Authorized Field Change

AFC 11928

Subject: Heater Supply Pipe Change

Certain WorkStar® vehicles built with MaxxForce® 11 or 13 2010-emission engines may experience leaks in the single-piece water pipe. The purpose of this AFC is to replace the single-piece water pipe with the three-piece water pipe on WorkStar® models.

Figure 1 EGR Crossover Pipe (Rear of Engine)

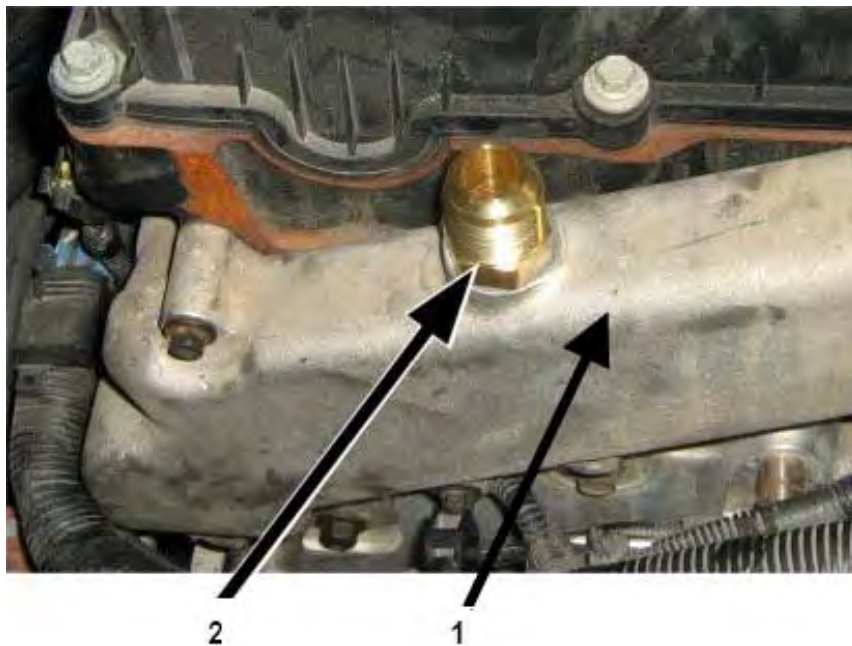
1. Park vehicle on a flat surface, shift transmission to park or neutral, set parking brake, and block wheels to prevent the vehicle from moving in both directions.
2. Raise hood assembly.
3. Drain the coolant using the Navistar Coolant Management tool.
4. Remove engine housing cover. (NOTE: It may be necessary to remove trim panels on some models and trim levels.) On ProStar® and TransStar® models with the deluxe interior, removal of the driver and passenger seat and floor mats is necessary.
5. From inside cab, locate EGR crossover pipe (coolant manifold) (See Figure 1, page 3) at the rear of the engine.

6. Remove the single-piece water pipe at the flare fitting end leaving the brass fitting in place in the EGR crossover. NOTE: Hold the brass fitting with a wrench when removing the flare fitting as this is an O-ring seal. The torque on the O-ring fitting should be maintained at 15-18 ft-lb (20-25 N•m). The torque on the flare nut should be 44-55 ft-lb (60-75 N•m). Remove the two fasteners holding the pipe to the EGR cooler housing. Disconnect the front end of the single-piece water pipe from the heater supply hose.

Figure 4 Attaching Supply Heater Pipe to Engine

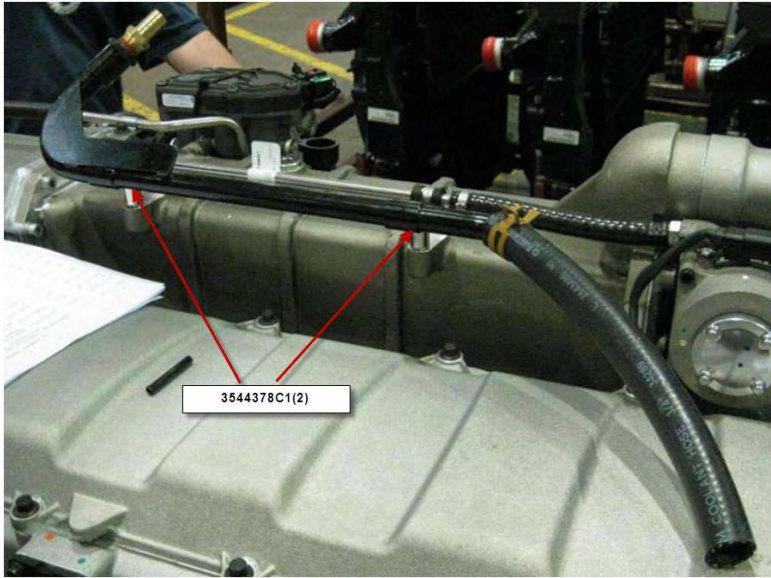
9. Add the 15 in. (380 mm) hose section onto the rear end of the curved pipe that mounts to top of the engine BEFORE installing on engine. Use P80® lubricant on hose and pipe for assembly. Install hose approximately 1 in. over the raised flare on the pipe.
10. Add the Mubea #27 clamp to the step 9 assembly.
11. Install step 10 assembly onto engine and fasten down using the 2 M6 Hex Flange Nuts (See Figure 4, page 6) that were removed in step 6.
